PlanGrid Task Report - Feb 14, 2024

4.9 Mechanical Test &
Balance

L04916_Princeton Woods FSU (Dumfries, VA)

#123 [CNTL 098] Ansul pull labeling.

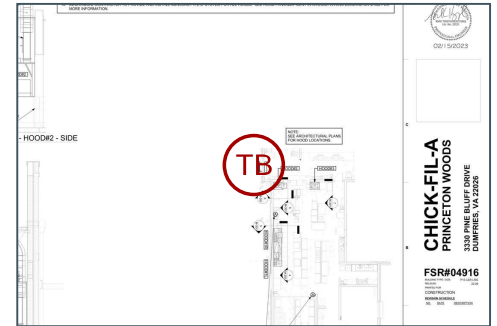
Label all Ansul pull stations
for which hoods they serve.

#122 [CNTL 107] (MISC) Missing Ansul pull stations

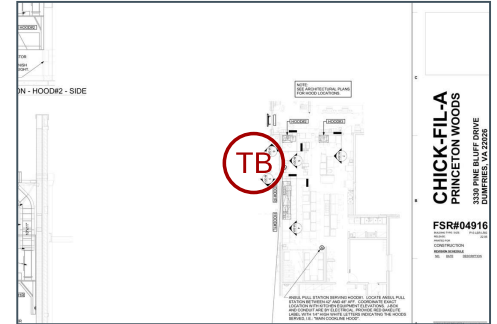
Ansul pull stations are not yet installed at locations designated

#121 [CNTL 107] (MISC) Zone Damper Thermostats do not have power

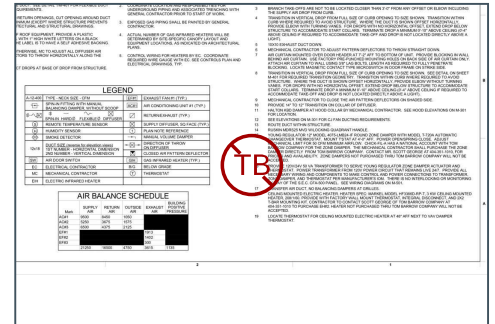
Description
Thermostat controlling zone dampers need transformer installed in order to power thermostats

#120 [EXHA 127] Grease exhaust duct is not supported.

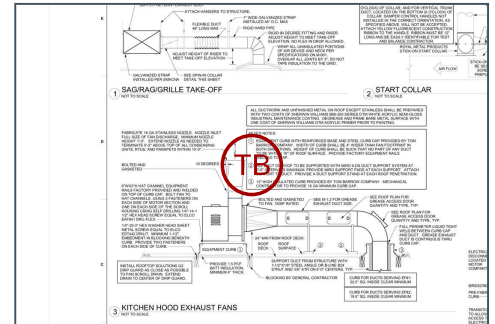
Exhaust duct for EF#1 is to be supported per kitchen hood exhaust fan detail on 6'0" centers.

#119 [UNIT 152] Trane equipment missing field kits.

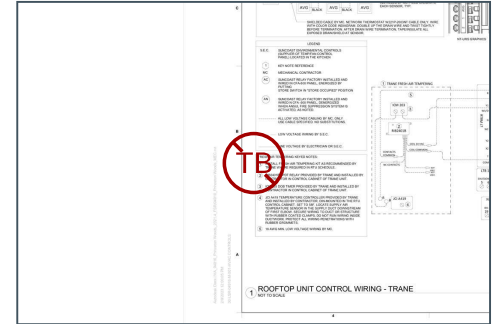
Trane equipment does not have additional manufacturer supplied, field installed relays, delay timer, or discharge temperature controller with FAT scheduled in design.

#118 [UNIT 168] Equipment not secured properly.

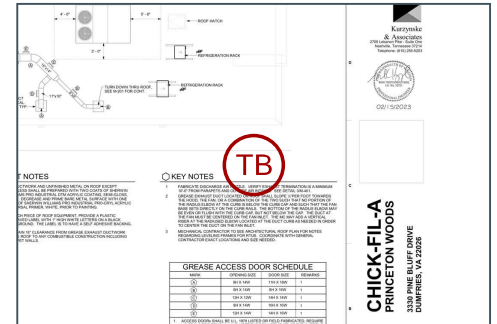
Equipment not secured properly to curb, high wind/ seismic clips not installed. Mechanical stated that unit package did not come with seismic clips.
